08 Pinout and packaging: orbit_demo, sky130hd layout variant sep

Package section 08_pinout_packaging of orbit_demo_design_review, written 2026-10-06 from the package files and the repository at commit 0495cfa. Links are relative to this file. Paths written as build/..., viz/..., site/... or docs/research/... are repository paths that are not copied into the package. Discrepancies are listed in the discrepancy register (09_review_notes).

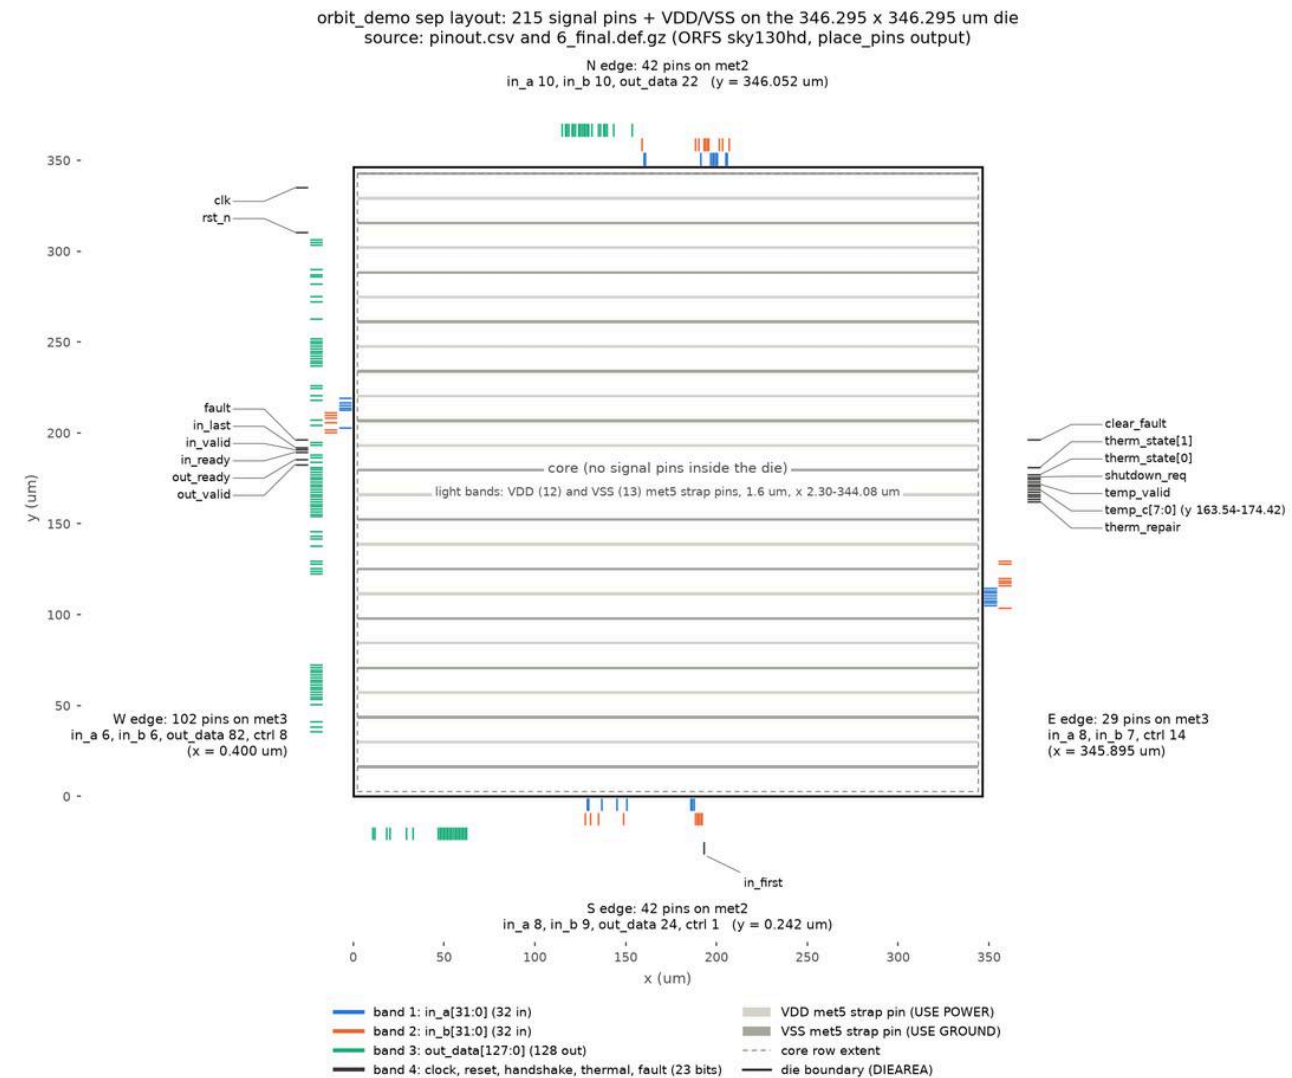
fault (W edge) and clear_fault (E edge) sit on opposite die edges at the same y = 196.180 um.

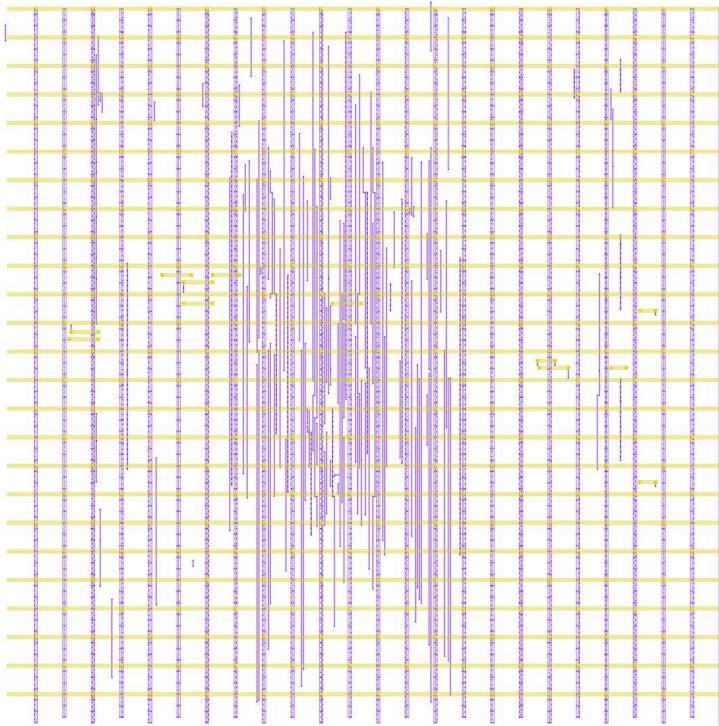
Supply	VDD, VSS met5 strap pins	The only supply connection points are the 12 VDD and 13 VSS horizontal met5 straps (1.6 um wide, x 2.30-344.08 um, 27.2 um pitch). They connect through met4 stripes and met1 followpins to every cell's VPWR/VPB (VDD) and VGND/VNB (VSS). One voltage domain. There are no power pads or bond pads; the next level must contact these straps from above or route to them. Static IR drop at 1.80 V and default activity: VDD worst 0.454 mV, VSS worst 0.628 mV (0.03 %)	6_final.def.gz decompressed lines 18347-18376 (PINS), 19239-19240 and 23252 (SPECIALNETS); 6_report.log lines 29-49; re-run ir.log lines 5-42; tech LEF read by the run: 1_synth.log line 7 (limits read from the image copy on this host, ASSUMPTION same file)	Geometry VERIFIED; IR VERIFIED and REPRODUCED 2026-10-06 (OpenROAD PSM, no VCD/SAIF); PSM EM currents at default activity are in ir.log (maximum resistor current 4.05e-04 A VDD, 4.33e-04 A VSS; REPRODUCED 2026-10-06) but were not checked against the DCCURRENTDENSITY limits of the tech LEF sky130_fd_sc_hd.tlef (MISSING); supply voltage specification and per-strap current budget MISSING
